Request for Class II Permissive Change(C2PC)

FCC ID: VG8XM9P02YYP

Please be notified that we, the undersigned, **Guangdong Midea Kitchen Appliances Manufacturing Co., Ltd.** declare that the reasons for this class II permissive change are as below:
This is a C2PC application for which the previous grant was issued on 05/12/2023.

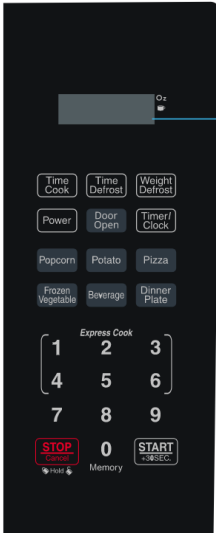
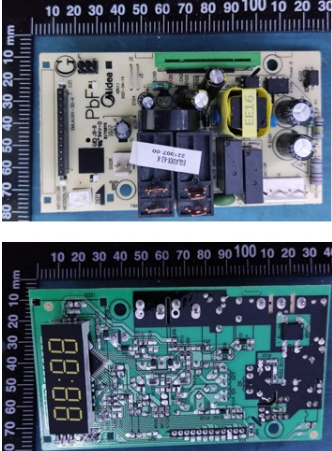
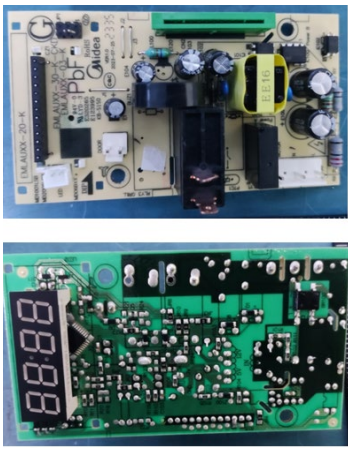
No.:	Original	New	Difference(s)
1			Keypad: Updated front keypad to accommodate child lock function (Child resistant oven door function)
2			Mother board: Modified the peripheral circuit (non-RF circuit) and some individual components and PCB layout. The magnetron and other circuit are exactly same as before

3	Not Applicable		The new one adds a solenoid valve locking mechanism, the original is not.
---	----------------	---	---
